Re: Joseph M. Farley Nuclear Plant - Units 1 and 2
Diesel Generator Technical Specification Change

Safety Evaluation for Proposed Changes
to the FNP-1 and 2 Technical Specification
Section 3/4.8.1.1 A.C. Sources - Operating

FIGURE 1/F SAR FIGURE 8.3-3

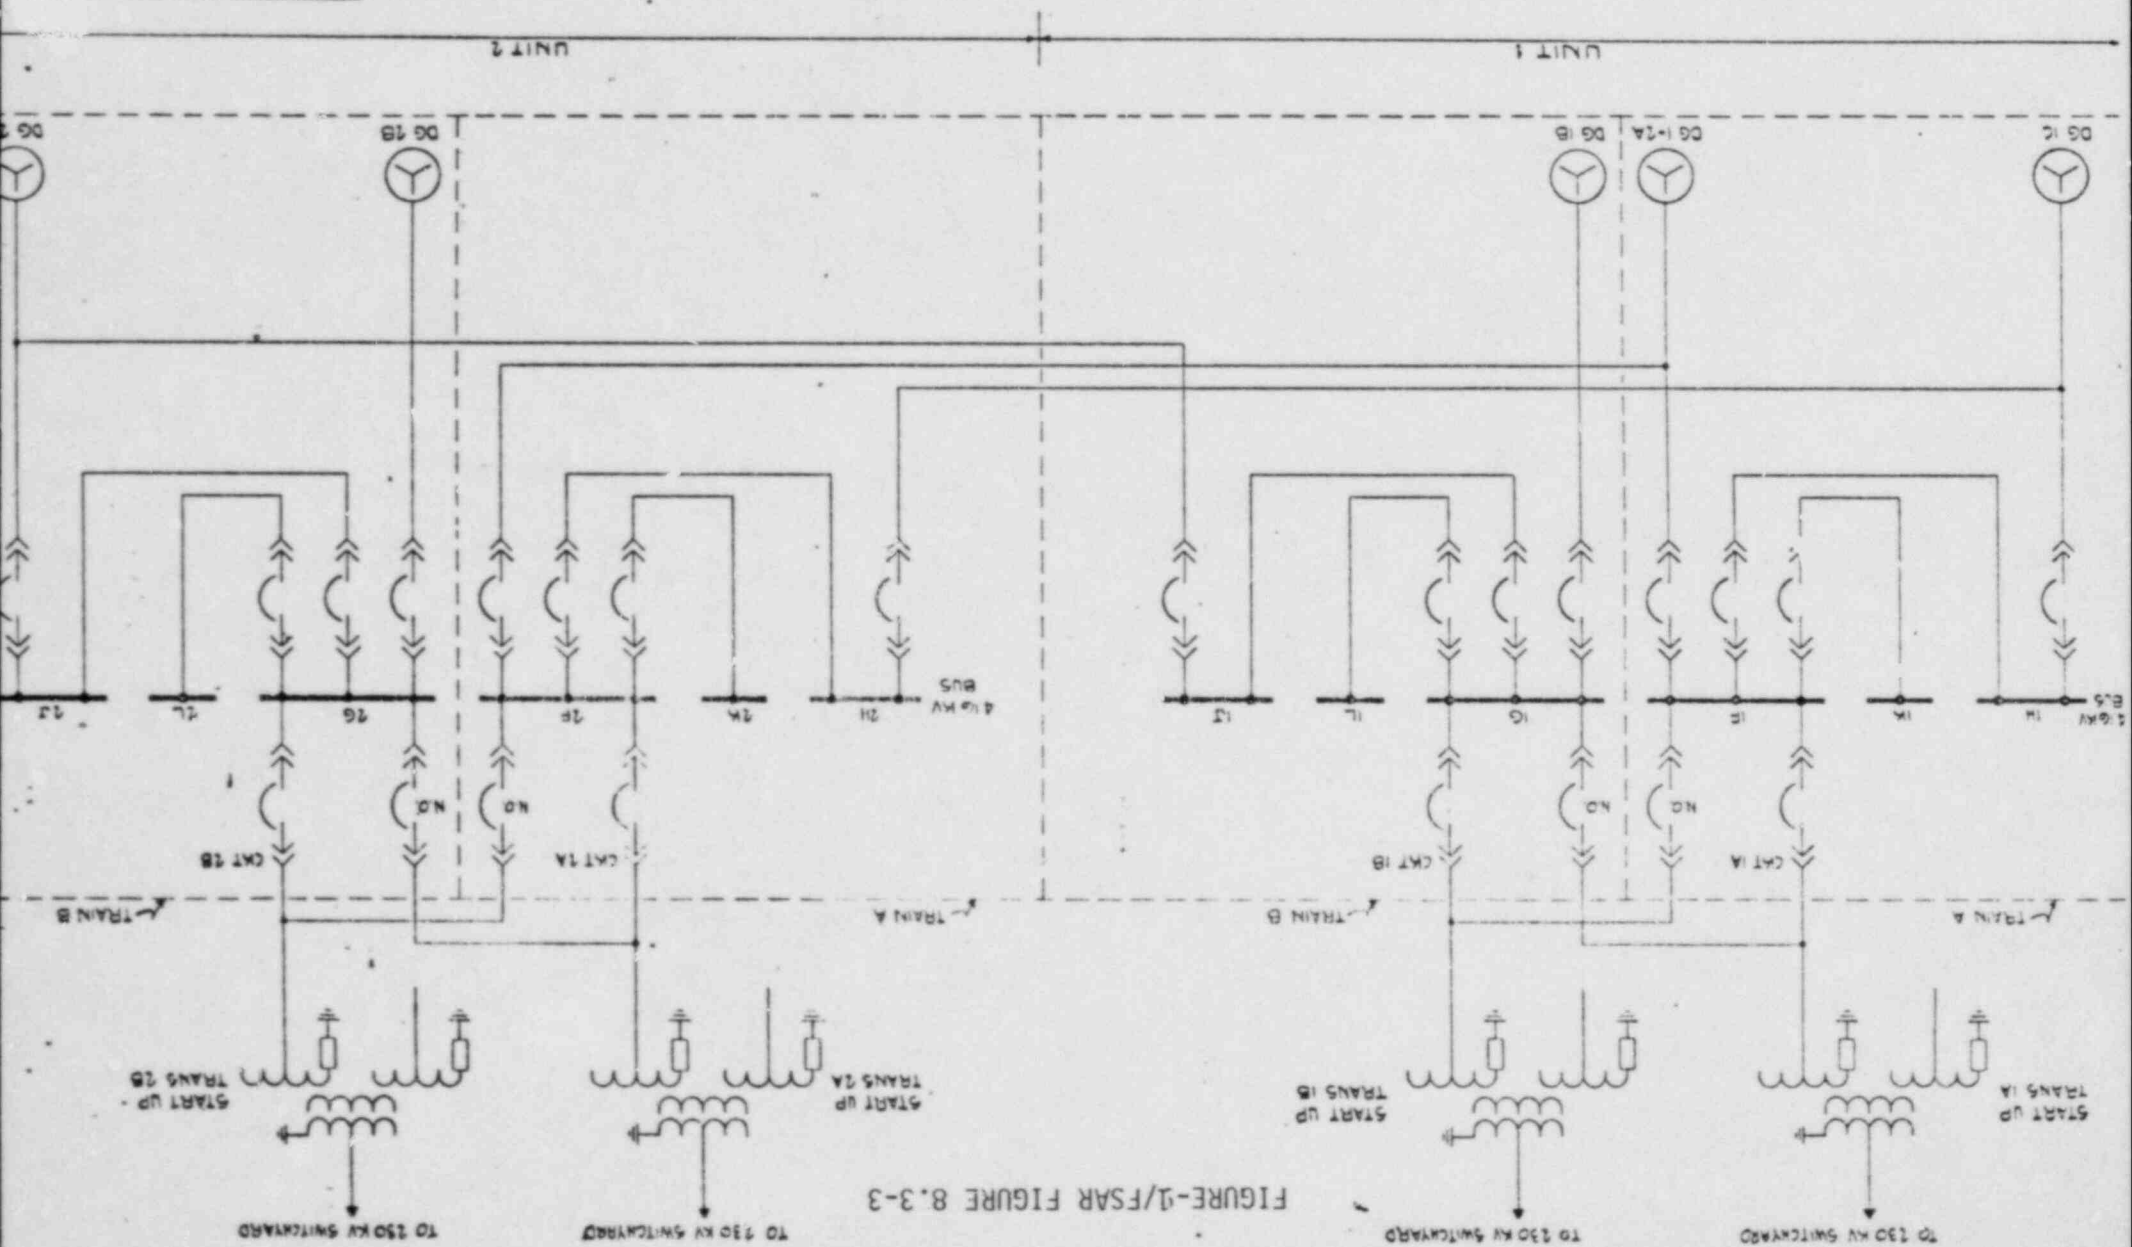
The capacity of the diesel generators ensures that sufficient and redundant power will be available to provide for the functioning of required emergency loads during the worst case loading conditions. The arrangement is shown in Figure No. 1, FSAR Figure 8.3-3.

The diesel generator system is the standby onsite power supply for the 4160V emergency distribution system (Figure 1, FSAR Figure 8.3-3). The power source for the distribution system is normally supplied by the offsite AC sources feeding the high voltage switchyard. The high voltage switchyard supplies these emergency buses via the startup transformers. The emergency power system has been designed and constructed with an emphasis on high reliability. This reliability is achieved through the use of the redundancy of equipment and power sources (Figure 9) that can be summarized as follows:
